Christ Church Primary School
Hampstead, London NW3

Heritage Statement

Revision A - March 2015 (addenda to consent 2014/5699L&P)

6.1 Schedule of Amendments

Ground floor plans as existing and as proposed

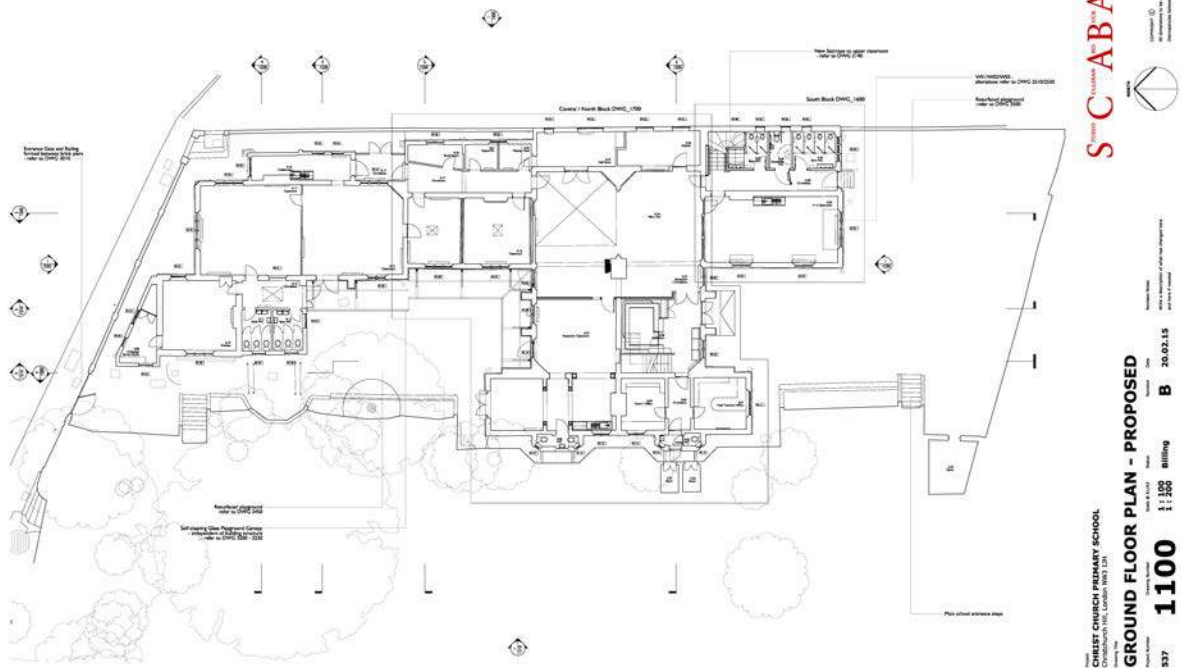
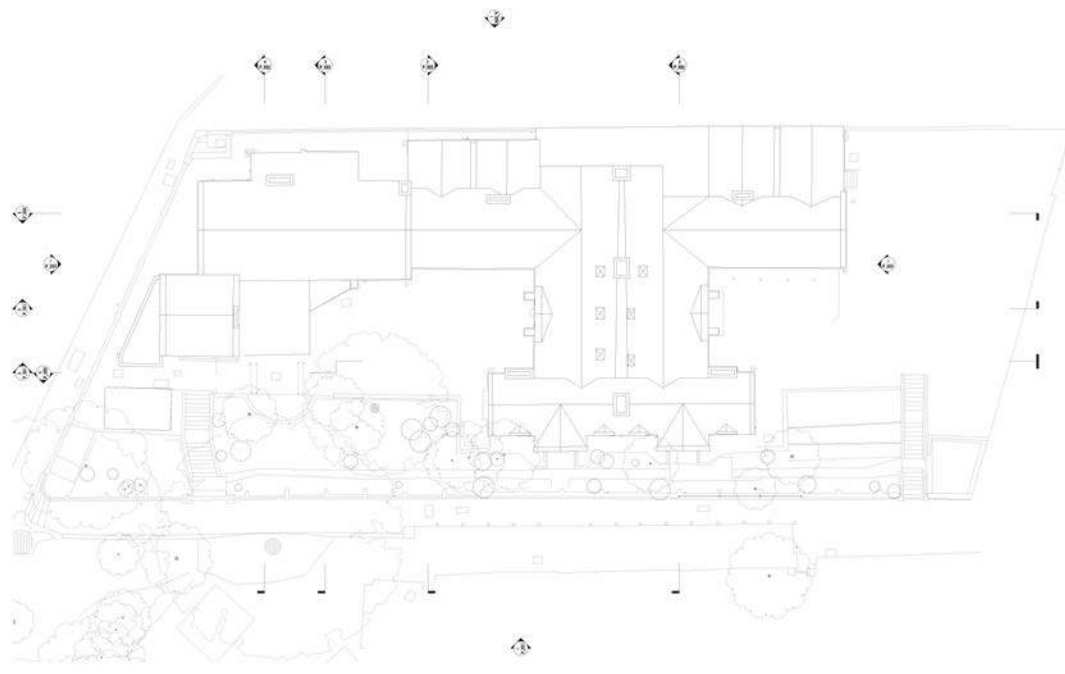
- 1.01 The kitchen and hall are retained in their existing location and are not transformed into a new classroom and admin rooms. The admin spaces in the North Block are therefore also retained in their existing location,
- 1.02 The classrooms in the northern end of the school are retained in their existing location (including the dividing screen) and not formed into a new kitchen and main hall,
- 1.03 New Link porch (0.17) is omitted,
- 1.04 Door from the Yr3 classroom (0.18) to the northern playground is omitted,
- 1.05 New dormer window to the south wing mezzanine classroom is omitted,
- 1.06 External storage wall and porch by new Christchurch Hill entrance is omitted,

- 2.01 Hall Timber Floor: Previously the hall was to become a new classroom and admin spaces and was to be carpeted. Now that the hall remains in its current location we will need to replace the existing timber floorboards as they are in a very poor condition, can no longer be sanded and are dangerous to the children (splintering etc.) The floor finishes proposed throughout the school are a like-for-like replacement.

Roof plans as existing and as proposed

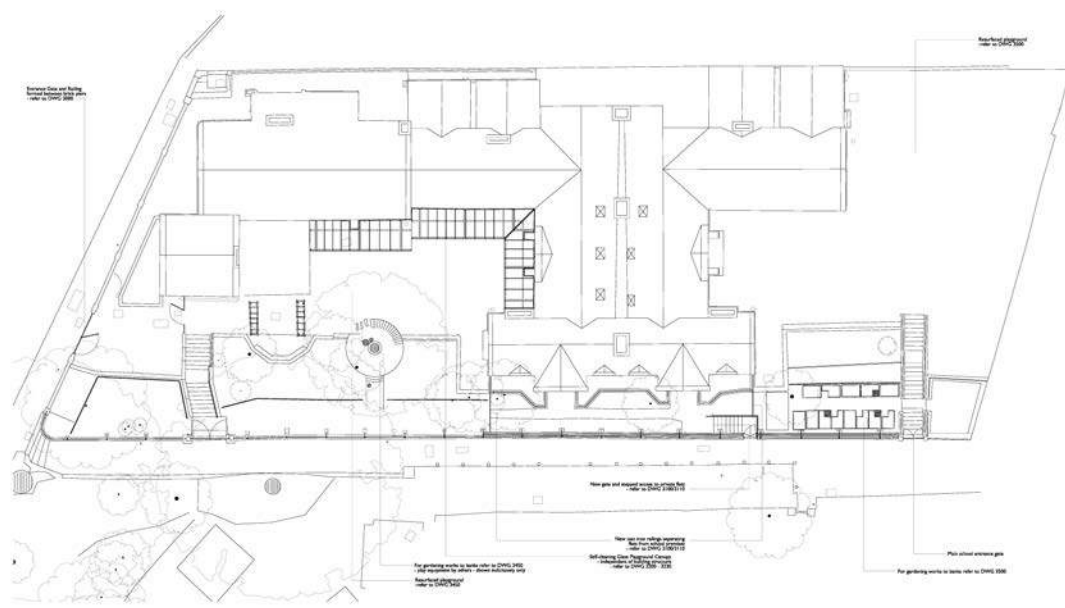
Impact: The new condenser will replace existing ones in a discrete and visually concealed location on the roofs, preserving the character and setting of the heritage asset and conservation area.
